# Site Plan - Sprouts

Commercial site plan and sign variance for  
a food and beverage sales (grocery) store  
with retail (Case 24-114).

Site Conformance Table

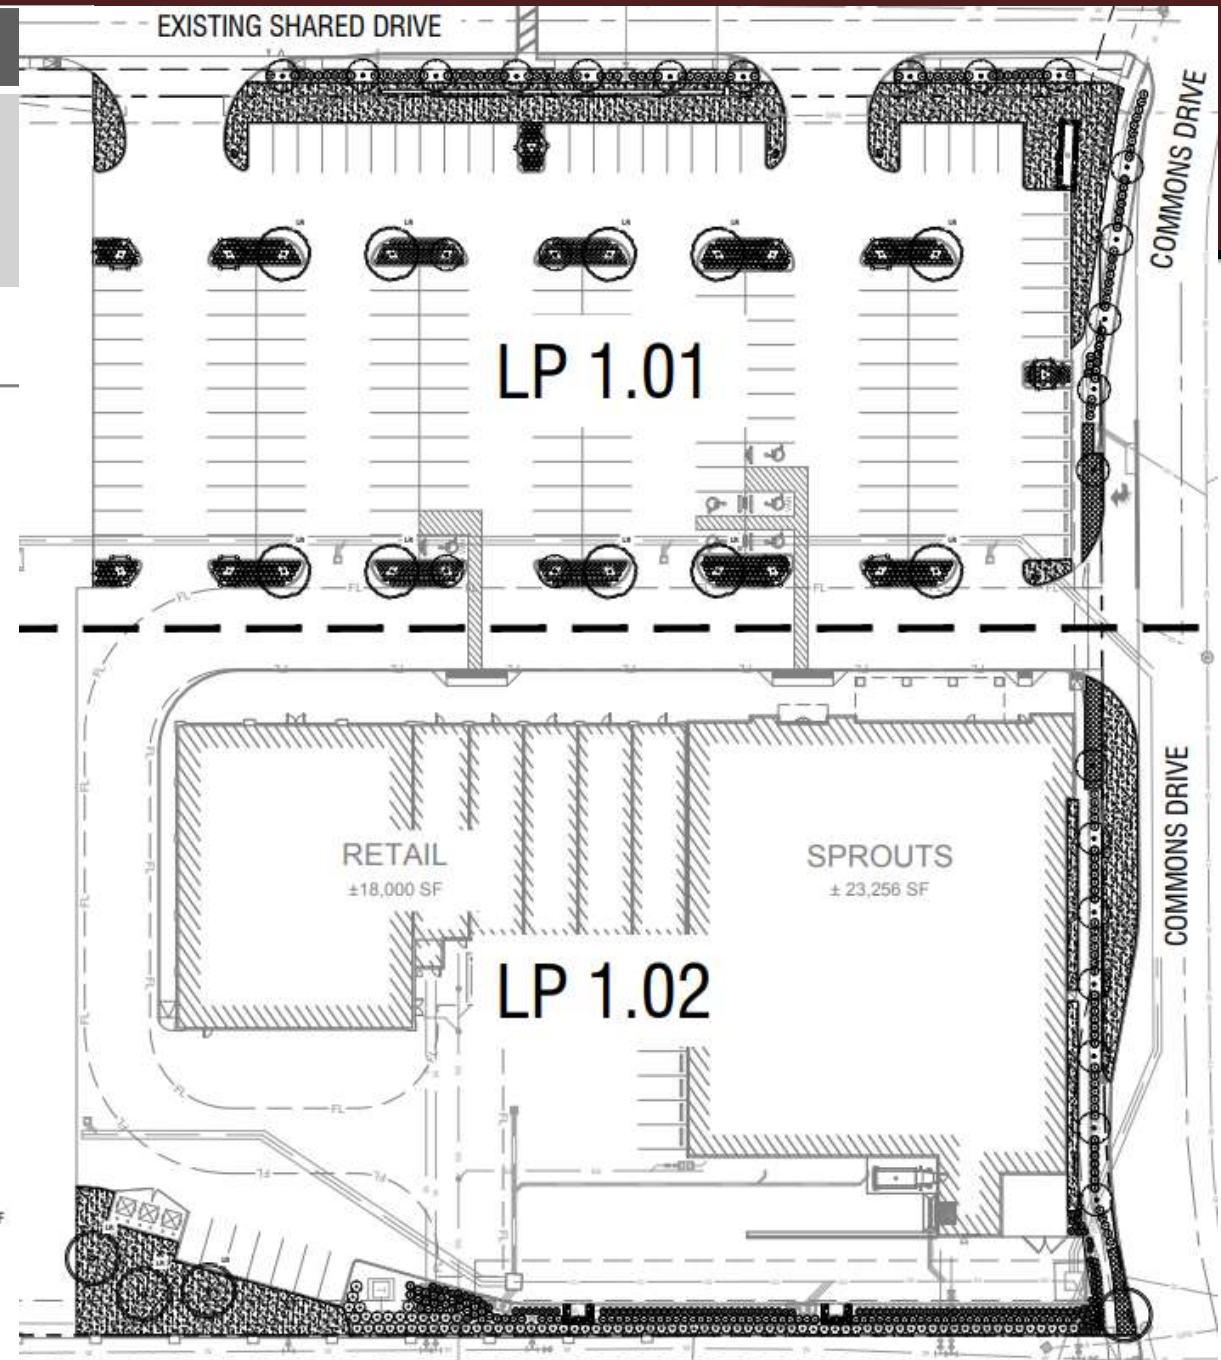
<i>Required</i>	<i>Staff's Findings</i>
<u>Lot Size, Coverage and Setbacks</u> Specific lot information as shown on site plan	<b>Complies.</b> Site plan is in compliance with all development regulations with the exception of the sign variance request(s).
<u>Landscaping –</u> 20% of Total Site shall be landscaped: 17,145 S.F.	<b>Complies.</b> Landscaping proposed: 17,164 S.F. with credits as listed on landscaping plans.
<u>Parking Requirement –</u> 1 space per 200 SF:207 spaces (landscape credit reduction to 187 spaces) 6 ADA spaces (2 for vans)	<b>Complies.</b> Parking provided: 187 spaces ADA spaces: 6 spaces (2 for vans)
